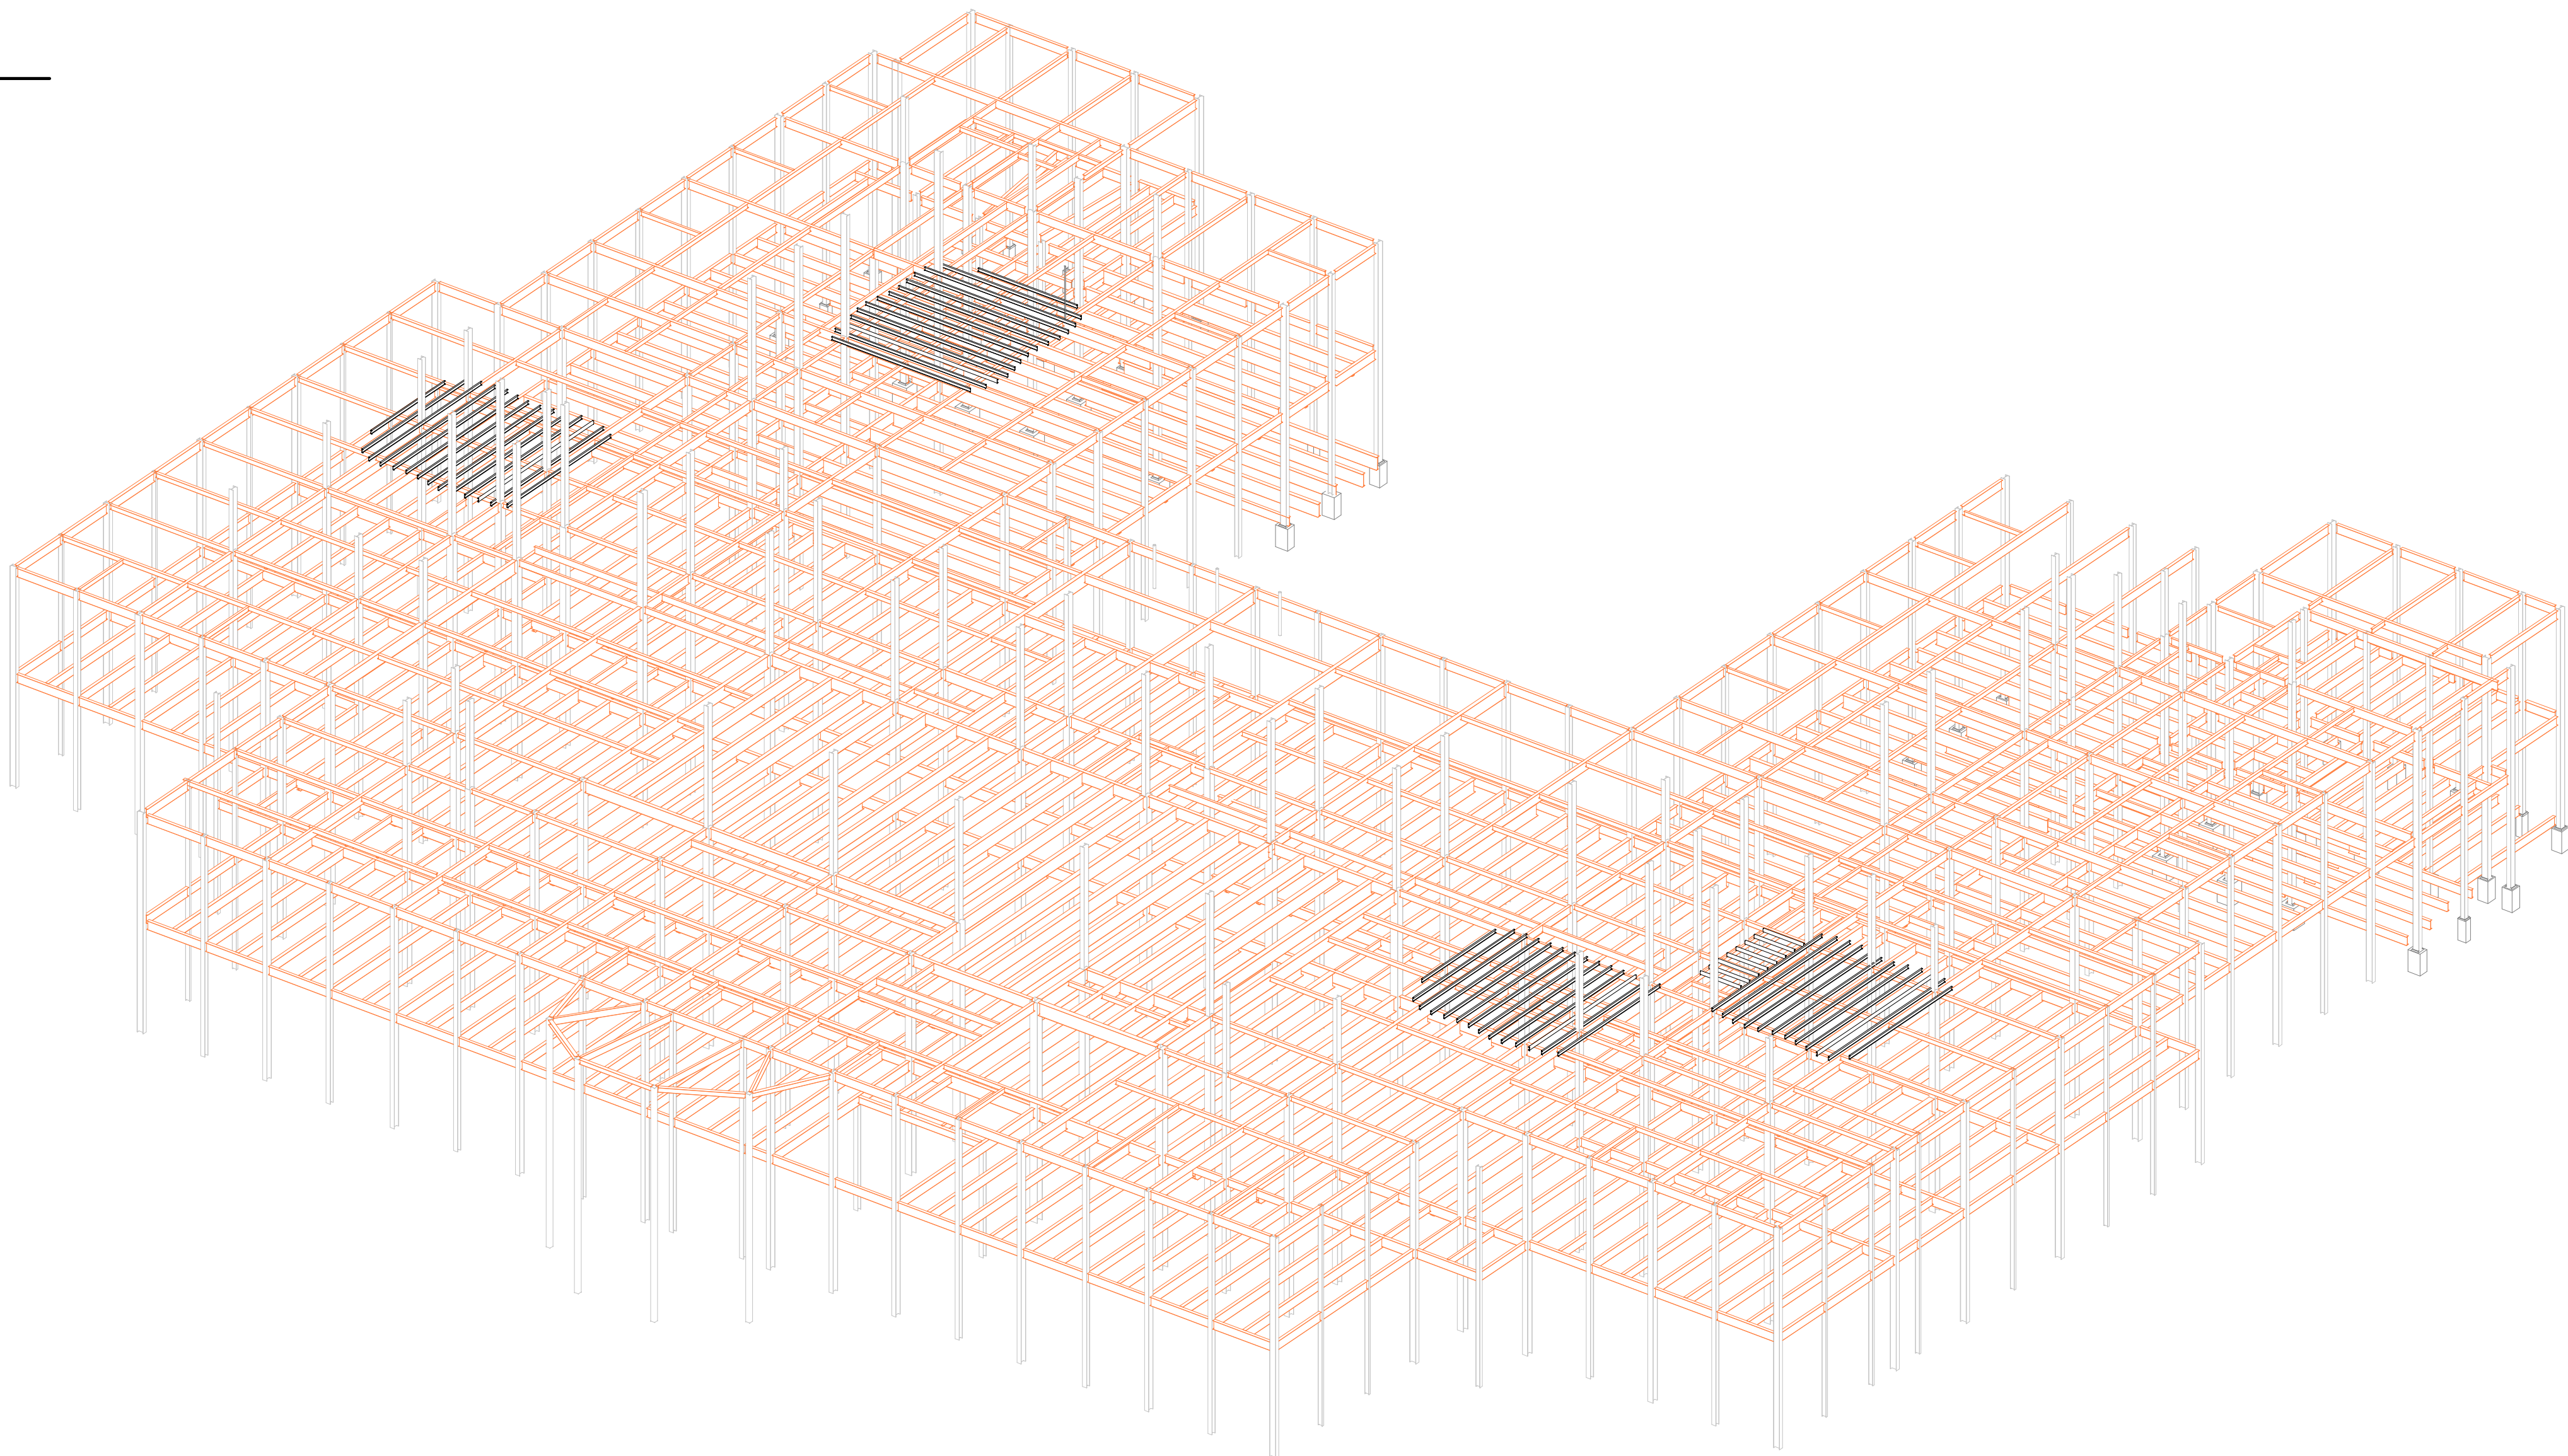
1. In Detail 5, where is CFSF (Item 4) that the vertical sheathing is attaching to?
2. Confirm 16" OC for the framing spacing.
3. Is it intended that the top and bottom track span the ~7' to 8' between beams.

Are posts only at steel beams?

Also, need size, thickness, top and base plate information.

Is the CFSF only at beam locations to support decking?

Or provide spacing for the angled framing members.
